Hi-Fi Products
Service Bulletin

Model: CDP-411

No. 397

Subject: "No Disc" Appears during Play

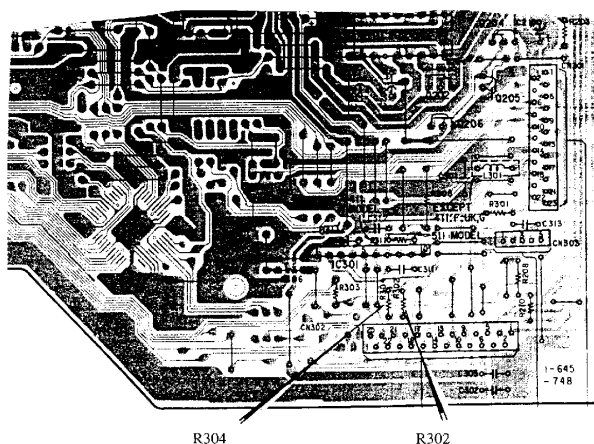
Symptom:
(51)

During the Continuous play mode a "No Disc" indication will appear in the display.

Change the value of the parts listed below.

REF	FORMER		NEW	
	DESCRIPTION	PART NUMBER	DESCRIPTION	PART NUMBER
R304	1K OHM	1-249-417-11	330 OHM	1-249-411-11
R302	1K OHM	1-249-417-11	470 OHM	1-249-413-11
